**Review of Sandia National Laboratories'  
Mixed Waste Landfill Corrective Measure Implementation Plan  
and Fate and Transport Model:**

**Comments and Recommendations**

**February 7, 2006**

Prepared on behalf of:  
Citizen Action New Mexico

Figure 22. Simulated PCE groundwater concentrations for 100 realizations.

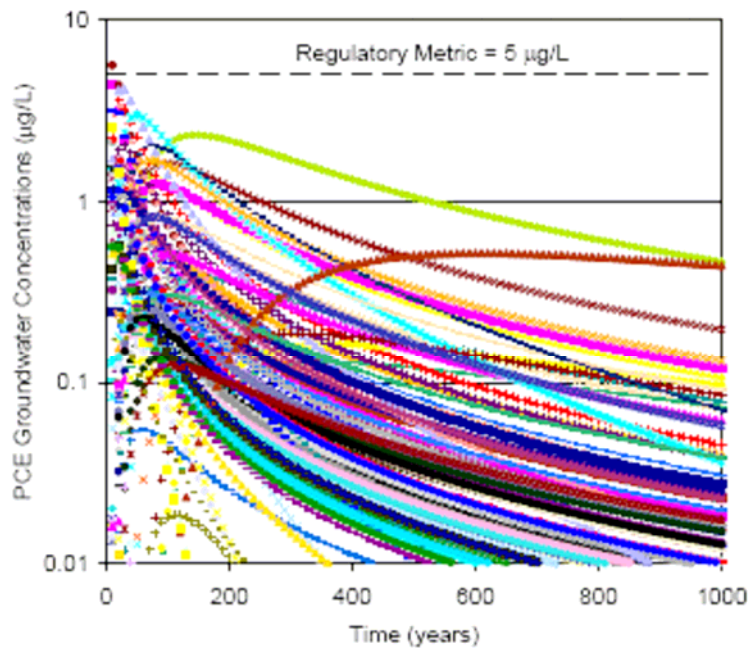
“Figure 22 [on p. 55] shows the simulated PCE concentrations in the groundwater as a function of time for all 100 realizations. **The majority of the realizations show the aquifer concentrations peaking before 50 years. Depending on the time of disposal, this corresponds to peak concentrations occurring by 2010 – 2040.** [emphasis added]. To date, no detectable amounts of PCE have been found in the groundwater at the MWL. This is still consistent with the simulations which show a large amount of variability in the simulated concentrations resulting from uncertainty included in the input parameters.” FTM at pp. 54-55. Figure 22 is attached these comments as APPENDIX A.

Thus, the FTM confirms that a volatile organic compound already shown to have escaped from the MWL, tetrachloroethylene (PCE), is likely to reach the groundwater aquifer within 50 years in most model runs. This finding should serve as a basis for NMED to focus a substantially higher degree of attention on the need for a corrective measure at the MWL that can be demonstrated to effectively control releases of VOCs.

The FTM should be revised to correct inconsistencies in data presented regarding PCE releases from the MWL. The FTM states that the maximum PCE detected in 1993 was 5,900 ppb at p. 52, but lists the maximum concentration of PCE in 1993 as 5,200 ppb on Figure 21 at p. 53.

**RECOMMENDATION:** Because PCE was shown to reach groundwater in all model realizations within approximately 50 years, the FTM should be revised to include model realizations reflecting future movement of all VOCs and SVOCs found to have been released from the landfill in 1993. These additional models and model realizations should be revised to include consideration of the decay products of PCE and the other VOCs and SVOCs that were shown to have escaped the MWL by 1993. Decay products modeled should include any decay products, such as vinyl chloride, that may have MCLs as low or lower than that established for PCE.

Figure 23. Cumulative probability for simulated PCE peak groundwater concentrations for 100 realizations.

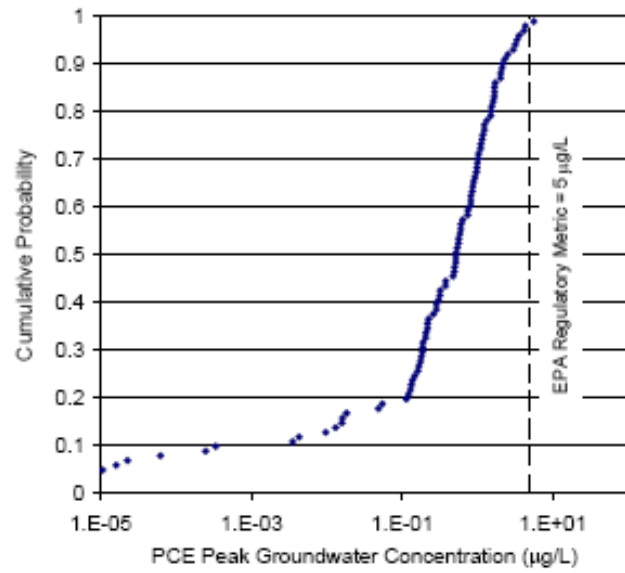
Figure 23 in the FTM shows the concentration of PCE anticipated in the groundwater by the model realizations. This figure shows that the vast majority of the realizations – about 80% - show PCE levels in the groundwater in the range of 1 – 5 micrograms per liter, equivalent to parts per billion. Prediction of those concentrations of PCE reaching the groundwater represent a prediction of significant contamination as PCE is not naturally occurring and therefore **zero** PCE would be predicted to have reached groundwater if no PCE were already shown to have escaped from the MWL. Figure 23 is attached to these comments in APPENDIX A.
